Planning, Zoning, and Building Department

BOARD ACTION REPORT – APPEALABLE ITEM

Project Name: 246 NE 6th Avenue
Project Location: 246 NE 6th Avenue
Request: Class V Site Plan and Architectural Elevations with two landscape Waiver requests.

---STAFF REPORT---

1 EXTERIOR ELEVATION WEST
SCALE: 1/8"=1'-0"

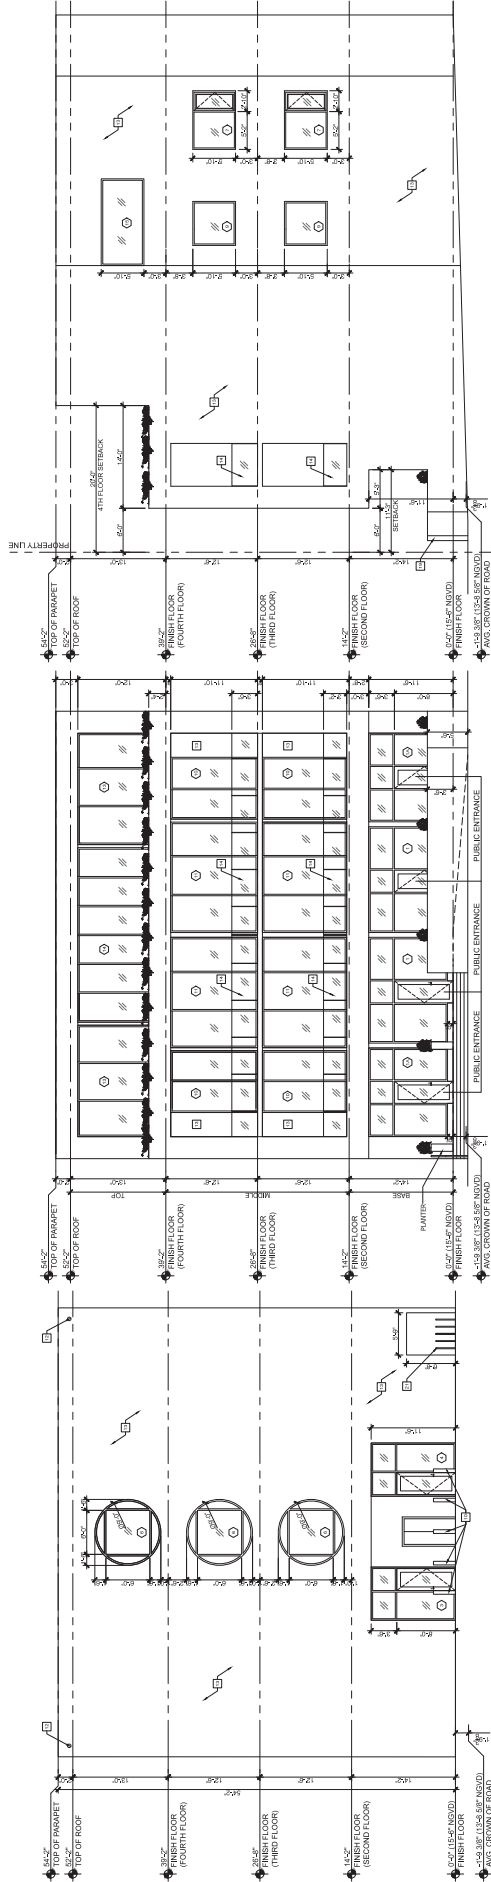
The design incorporates elements which directly contradict the CBD Architectural Design Guidelines (ADG):

- a. The ADG state, “The ratio of glass to wall emphasizes the solidity of the structure”. The ratio of glass to wall on the front façade is high and coupled with glass railings creates a transparent building façade that detracts from the solidity of the structure.
- b. The ADG state the style has a “system of punched openings vs. large expansive walls of windows.” The front façade is composed of expansive walls of windows, which is specifically called out as contrary to the style.
- c. The Characteristics listed on Sheet A-3.3 state the style has “Railings are glass, wood, or extensions of solid walls”. The guidelines actually state that, “Railings are **metal**, wood, or extensions of solid walls”. The proposed glass railings are not listed as one of the appropriate materials for the style.

Generally, the proposed architecture is more simple and stark than the guidelines demonstrate. There is no hierarchy among the masonry portions of the building; the cantilevered portion is the same thickness and mass as the base and the top, which appears incongruent with a “rational load bearing system.” Incorporation of forms to denote the building entry or reflect the building program, shade

devices, or the addition of accent materials such as wood or stone would add a layer of richness to the design that would be more consistent with the examples in the guidelines.

Pursuant to **LDR Section 4.4.13(F)(5)(a)2.**, all public entries, excluding emergency exits, shall be easily identifiable and integrated into the building architecture and use one of the frontage types in Section 4.4.13(E)(4). Each freestanding principal structure shall have a minimum of one clearly defined primary public entrance facing the street. The hardscape design denotes the access to the structure; however, the front facade demonstrates entry by simply incorporating doors within the storefront glass, which is only differentiated by a thin door frame and door handle.

Given the analysis above, staff recommends denial of the Architectural Elevations, based on findings that the front façade does not meet Standard 1, as the proposed design does not contribute to the image of the City as defined by the adopted CBD Architecture Design Guidelines by incorporating design elements (expansive glass walls with glass railings) that contradict the style, and Standard 3, as the proposed building will stand out from surrounding redevelopment as it does not contain sufficient architectural detail to be consistent with the CBD Architectural Design Guidelines (adopted, supplemental criteria)

1. Standard 1 as the proposed design does not contribute to the image of the City as defined by the adopted CBD Architecture Design Guidelines;
2. Standard 3 as the proposed structure is not in harmony with the CBD Architectural Design Guidelines (adopted, supplemental criteria); and
3. The Masonry Modern architectural style per LDR Section 4.4.13(F)(3)(a)(6).
